### Piper PA-32 (Cherokee Six) Series Aeroplanes

**AD/PA-32/79**  
**Amdt 1**

**Main Landing Gear Side Brace Stud**

Figure 1

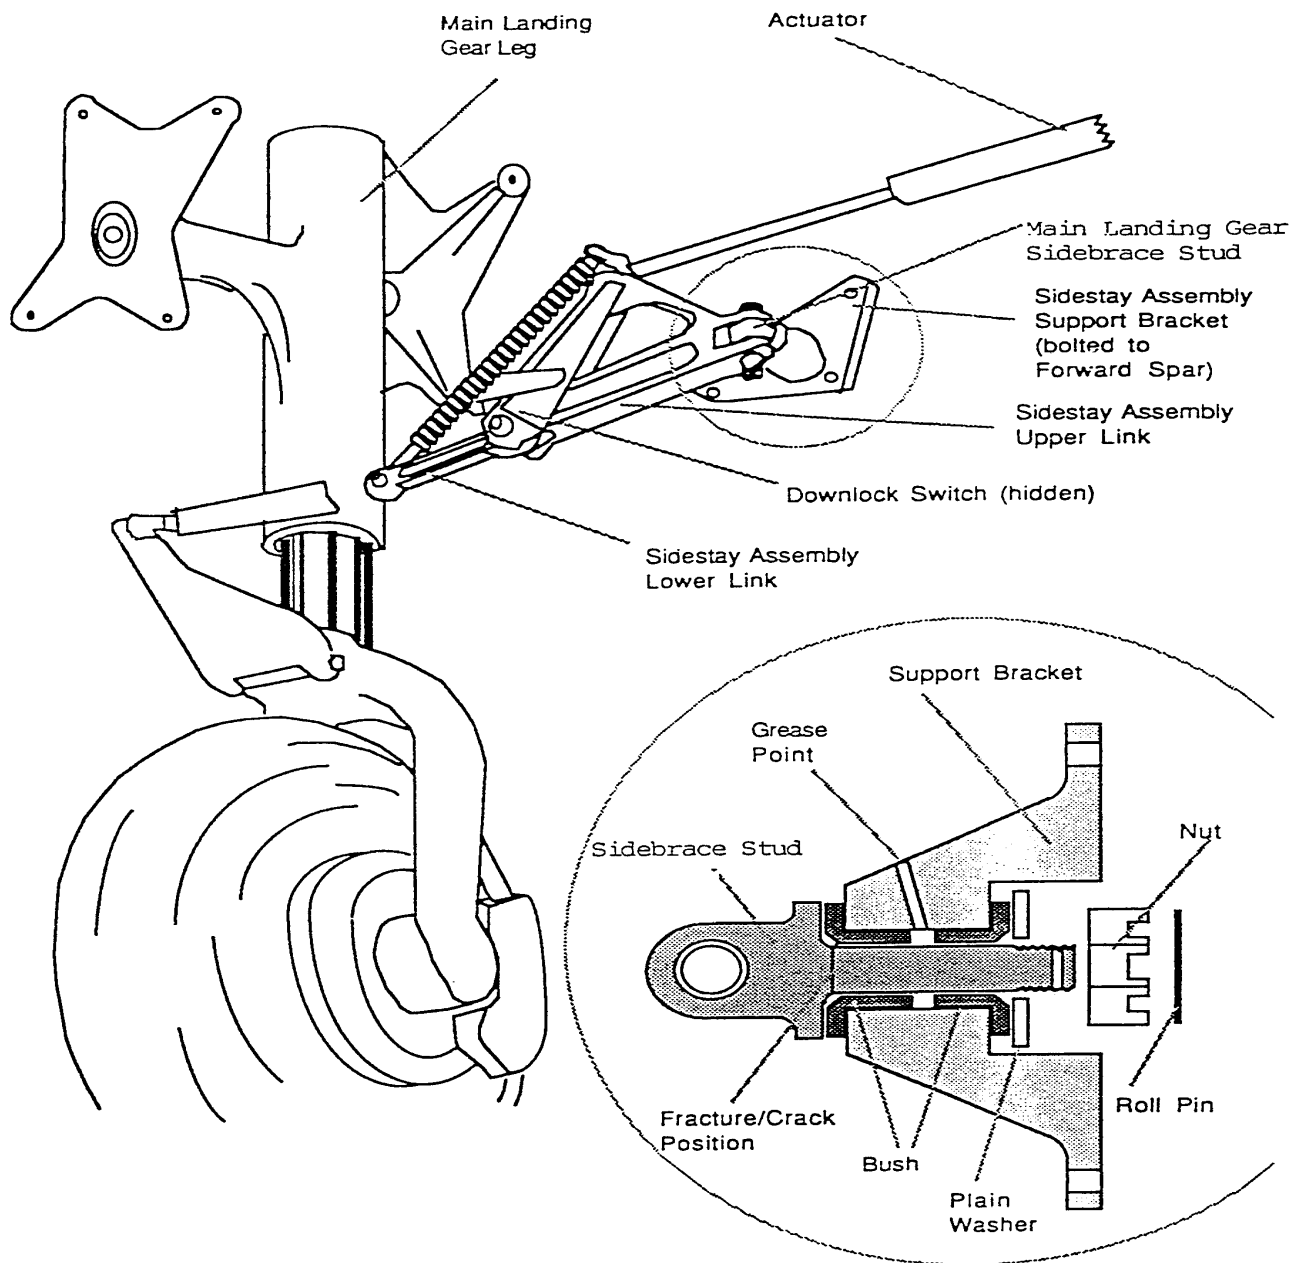
**Requirement:** Remove both the left and right main gear side brace studs from the aircraft in accordance with the instructions contained in the Landing Gear section of the maintenance manual, and inspect each main gear side brace stud for cracks using fluorescent penetrant or magnetic particle inspection methods. Figure 1 of this Directive depicts the area where the sidebrace stud is to be inspected.

This figure is provided to depict the area of the sidebrace stud to be inspected. This is not intended to represent the configuration of all models affected.

For any main gear side brace stud found cracked, replace the cracked stud with an approved serviceable part in accordance with the instructions contained in the Landing Gear section of the applicable maintenance manual.

For the affected Model PA32R-300 aircraft, ream the existing two-piece bushings to an inside diameter of 0.624 inch to 0.625 inch, chamfer the head side of the bushing to accommodate the radius in the shank of the main gear side brace stud, and install the 5/8 inch stud, P/N 78717-02. No repetitive inspections will be required by this Airworthiness Directive when this action is accomplished on both the left and right bracket assemblies. If the bushings cannot be reamed while installed in the bracket (i.e., the bushings are loose), then install a main gear side brace bracket assembly, P/N 95643-06, P/N 95643-07, P/N 95643-08, or P/N 95643-09, as applicable.
